FINAL PLAT

THE LEGACY ADDITION

Re: S/D 98-55 -- Final Plat of THE LEGACY ADDITION

STAFF REPORT

FINAL PLAT
THE LEGACY ADDITION
 AN ADDITION TO WICHITA, SEDGWICK COUNTY, KANSAS

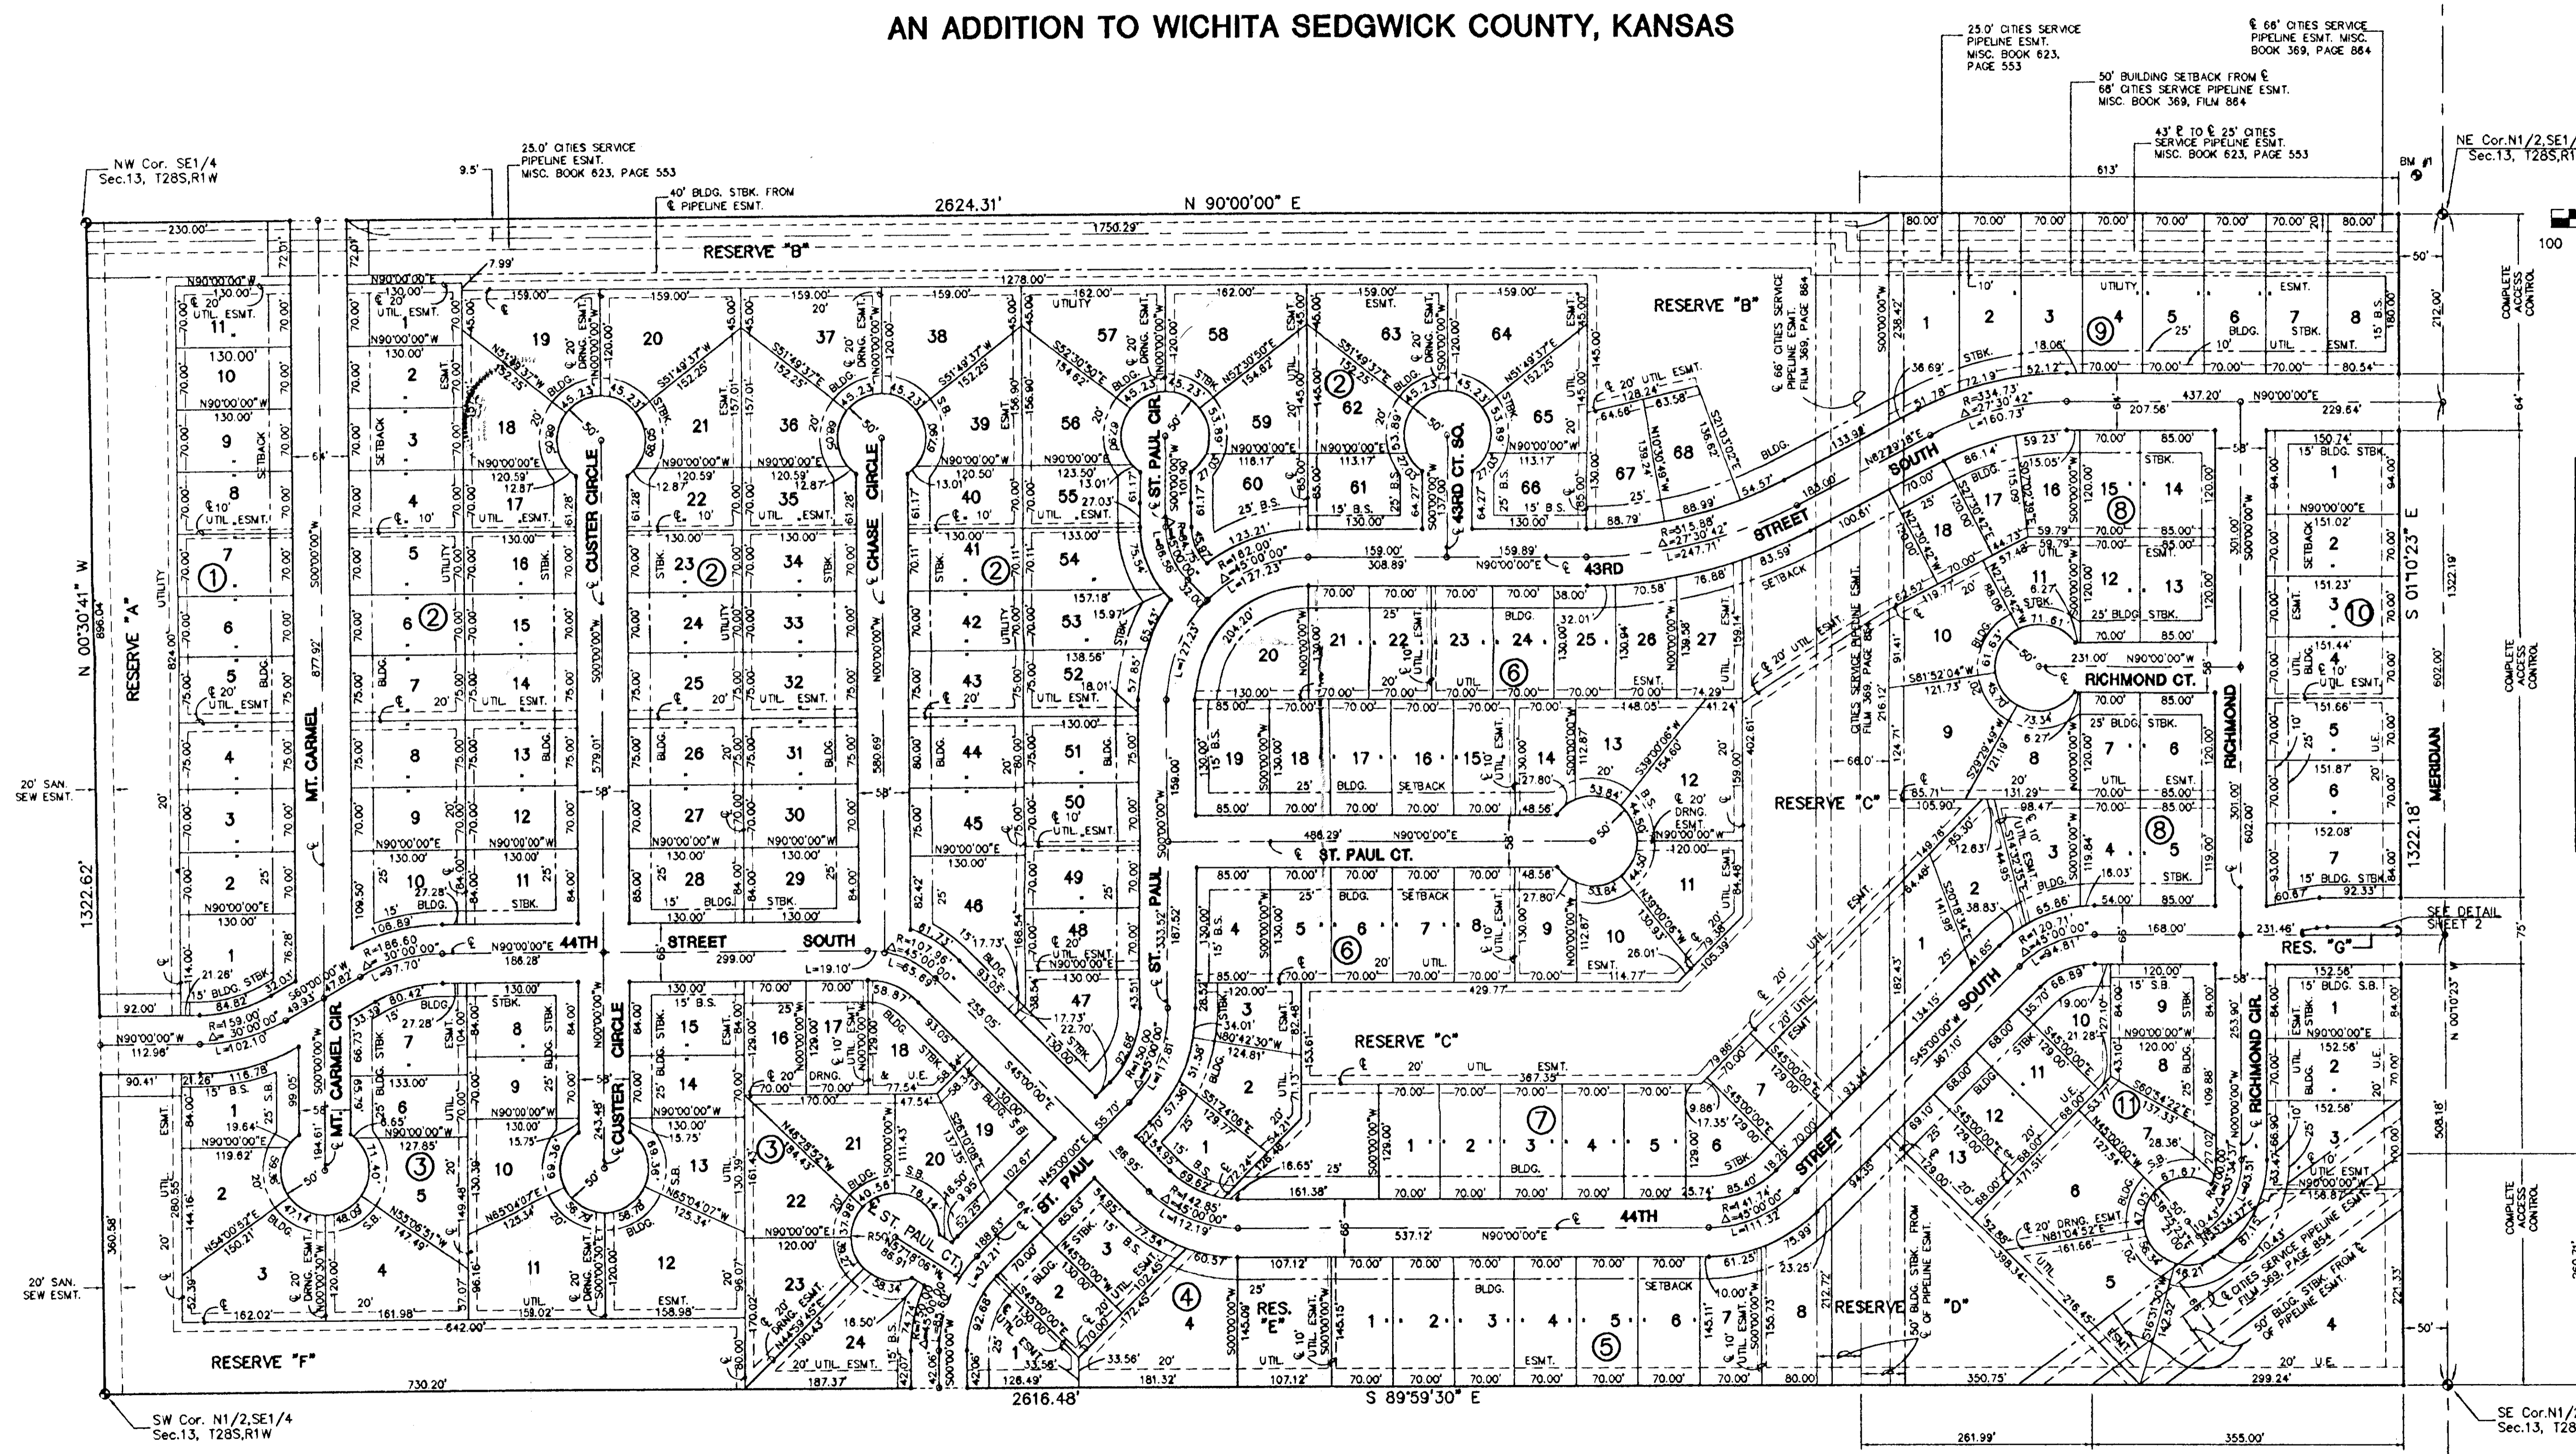
- C. City Engineering needs to comment on the status of the applicant's drainage plan. *The drainage plan is approved. The lots adjacent to the pond and drainage ditch need minimum building pad elevations.*

- E. The final plat tracing shall contain the appropriate name for the County Clerk, James Alford.
- F. This property is within a zone identified by the City Engineers' office as likely to have groundwater at some or all times within 10 feet of the ground surface elevation. Building with specially engineered foundations or with the lowest floor opening above groundwater is recommended, and owners seeking building permits on this property will be similarly advised. More detailed information on recorded groundwater elevations in the vicinity of this property is available in the City Engineers' office.

- G. The tie point at the southeast corner of the plat should be revised to reference the "SE 1/4".
- H. The applicant shall submit a copy of the instrument which establishes the pipeline easements on the property, which verifies that the easements shown are sufficient and that utilities may be located adjacent to and within the easements.

- I. The applicant's agent shall determine any setback requirements for the pipelines by researching the text of the pipeline agreements. If a setback from the pipeline easements is provided for in the pipeline easement agreements, it shall be indicated on the face of the plat.

- J. Lot 1 through 8 of Block 9 exceed the lot depth-to-width standard of 2½ to 1. A waiver from this provision will be needed for approval of the plat.

- M. A guarantee shall be provided for the installation of a temporary cul-de-sac for the termination of Mt. Carmel. The right-of-way dedication shall be provided by the plat or by separate instrument, with the vacation of the temporary cul-de-sac being effective upon the extension of Mt. Carmel northward.

- O. Fire Department needs to comment on Mt. Carmel which is 800 feet in length, exceeding the 600-ft standard imposed by the Subdivision Regulations. The length of Mt. Carmel is acceptable since it is a stub street. A temporary turnaround is required.

- Q. **Fire Department** needs to comment on the plat's street names. It would appear that St. Paul Circle should be renamed St. Paul Court. **Fire Department has contacted the Applicant regarding revised street names. Chase shall be renamed St. Paul. Chase Court shall be renamed St. Paul Court. 43rd Street South Court shall be renamed 43rd Court South.** \

- Y. The representatives from the **utility companies** should be prepared to comment on the need for any additional utility easements to be platted on this property. **KG&E and Southwestern Bell has requested additional easements which have been denoted on the final plat.**
